WASHINGTON NUCLEAR - UNIT 2

INSTRUMENTATION3/4.3.10 NEUTRON FLUX MONITORING INSTRUMENTATIONLIMITING CONDITION FOR OPERATION

ADDED → 3/4.3.10 NEUTRON FLUX MONITORING INSTRUMENTATION

FIGURE 3.3.10-1

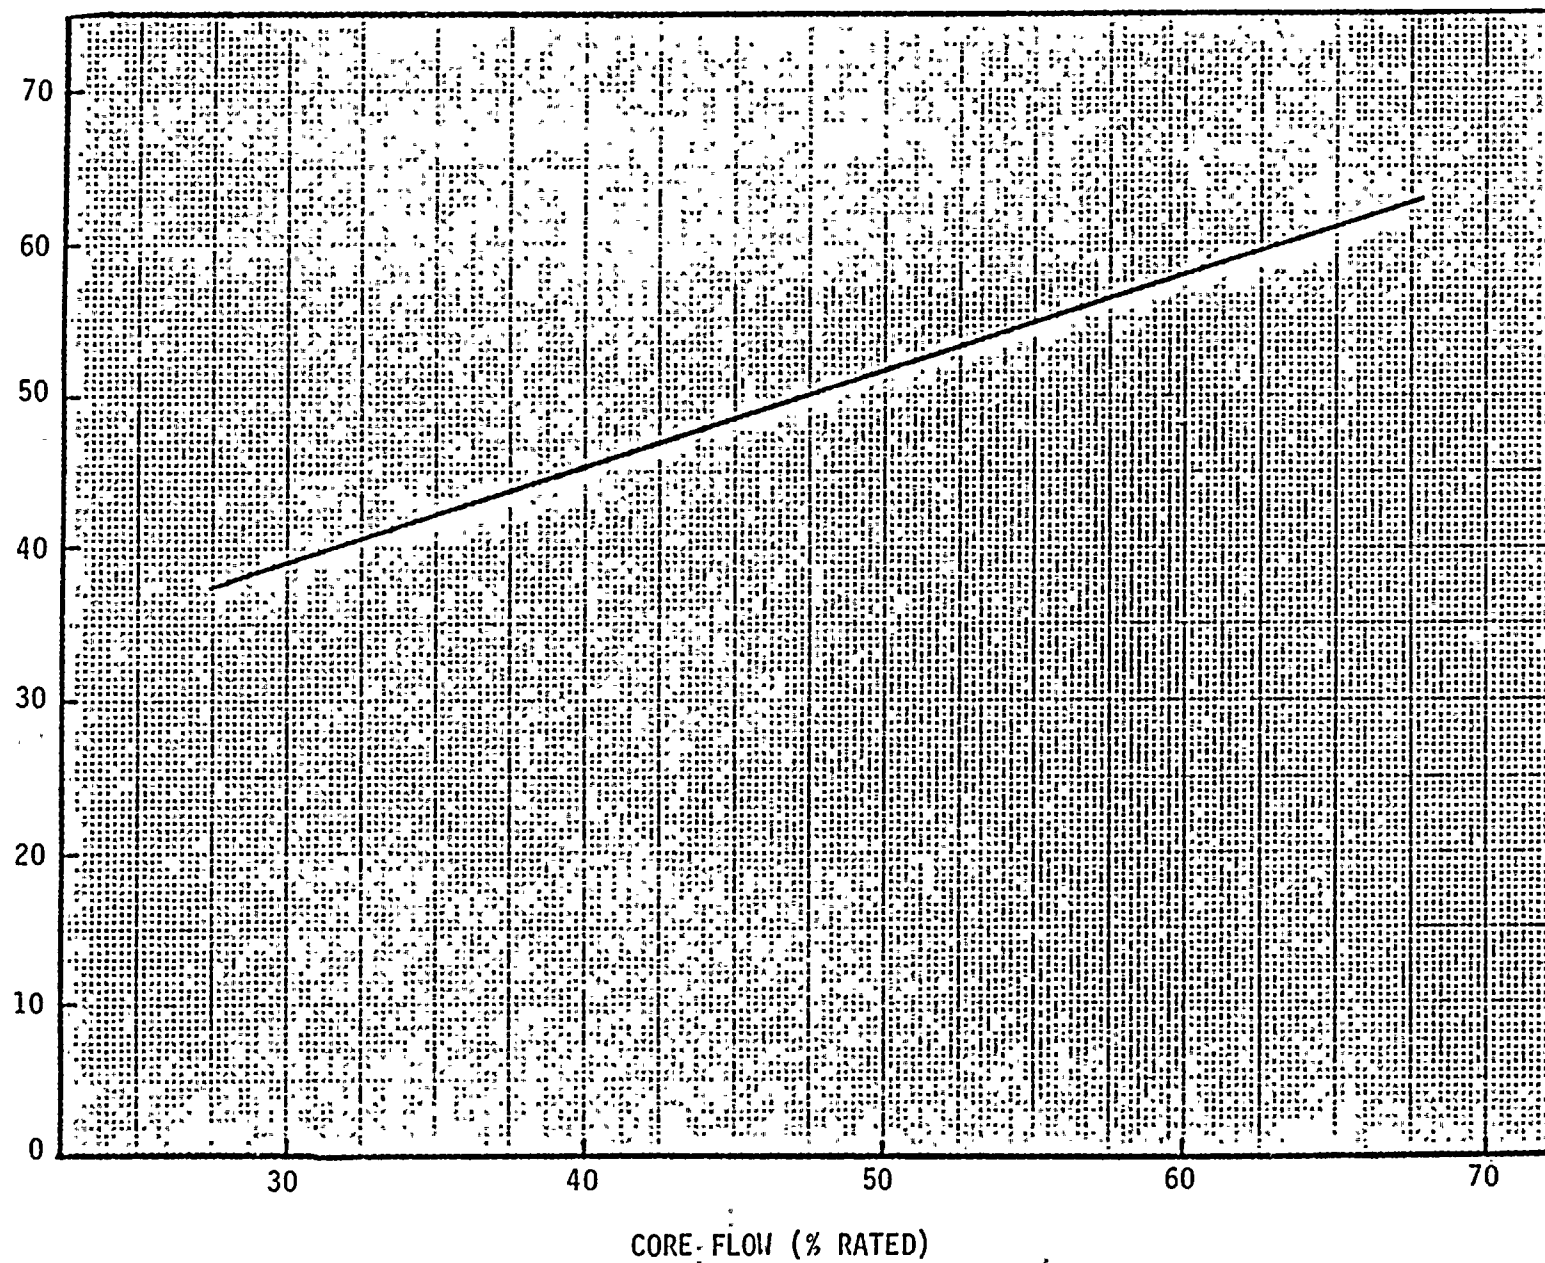
3.2.1-3	MAXIMUM AVERAGE PLANAR LINEAR HEAT GENERATION RATE (MAPLHGR) VERSUS AVERAGE PLANAR EXPOSURE, INITIAL CORE FUEL TYPE 8CR711.....	3/4 2-4
3.2.3-1	MINIMUM CRITICAL POWER RATIO (MCPR) K_f FACTOR VERSUS CORE FLOW.....	3/4 2-7
ADD → 3.3.10-1	→ THERMAL POWER LIMITS OF SPEC. 3.3.10-1.....	3/4 3-104
ADD → 3.4.1.1-1	→ MINIMUM REACTOR VESSEL METAL TEMPERATURE	
(SEE BELOW) 3.4.6.1-1	VERSUS REACTOR VESSEL PRESSURE (INITIAL VALUES).....	3/4 4-20

APPLICABILITY: OPERATIONAL CONDITION 1~~XX~~ ^{DELETE ASTERISKS} with two reactor coolant system recirculation loops in operation with THERMAL POWER greater than the limit specified in Figure 3.3.10-1 and total core flow less than 45% of rated total core flow or with one reactor coolant system recirculation loop not in operation with THERMAL POWER greater than the limit specified in Figure 3.3.10-1.

ACTION: With the APRM or LPRM* neutron flux noise level greater than three (3) times their established baseline noise levels, initiate corrective action within 15 minutes to restore the noise levels to within the required limits within 2 hours or reduce THERMAL POWER to less than or equal to the limit specified in Figure 3.3.10-1 within the next 2 hours.

#The baseline data obtained in Specification 4.3.10.3 is applicable to operation with one reactor coolant system recirculation loop not in operation and THERMAL POWER greater than the limits specified in Figure 3.3.10-1.

FIGURE 3.4.1.1-1

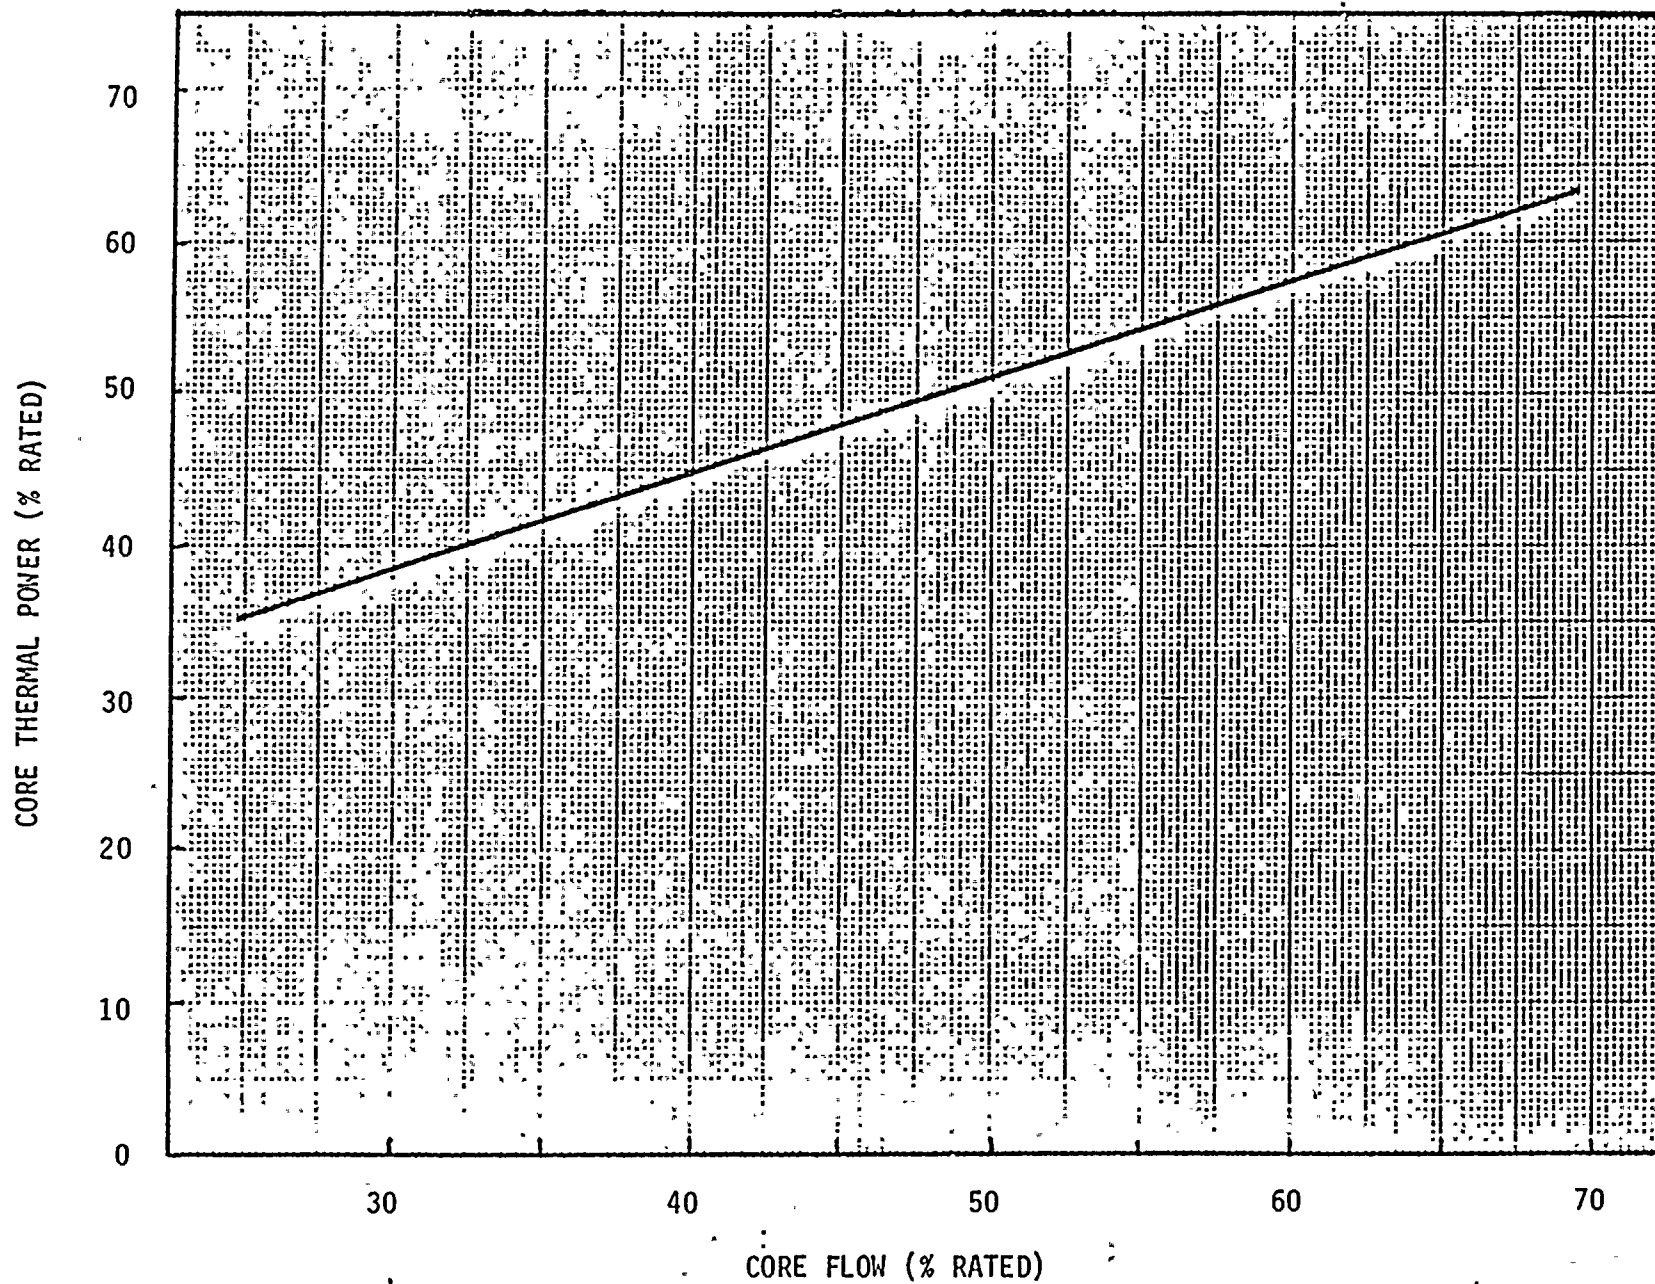
b) The THERMAL POWER shall be less than or equal to the limit specified in Fig. 3.4.1.1-1 or the provisions of Spec 4.3.10.3 are satisfied. With one reactor coolant system recirculation loop not in operation and with THERMAL POWER greater than the limit specified in Fig. 3.4.1.1-1, and the provisions of Spec. 4.3.10.3 having not been satisfied, initiate action within 15 minutes to reduce THERMAL POWER to less than or equal to the limit specified in Fig. 3.4.1.1-1 within 4 hours. The provisions

- i) With one reactor coolant system recirculation loop not in operation and THERMAL POWER greater than the limit specified in Fig. 3.4.1.1-1 and core flow less than 39% of rated core flow, initiate action within 15 minutes to reduce THERMAL POWER to less than or equal to the limit specified in Fig. 3.4.1.1-1 or increase core flow to greater than or equal to 39% of rated core flow within 4 hours.

[ADD ABOVE
TO 4.4.1.1.1]
d. Core flow is greater than or equal to 39% of rated core flow when core THERMAL POWER is greater than the limit specified in Fig. ~~3.4.4.1.1-1~~
3.4.1.1-1.
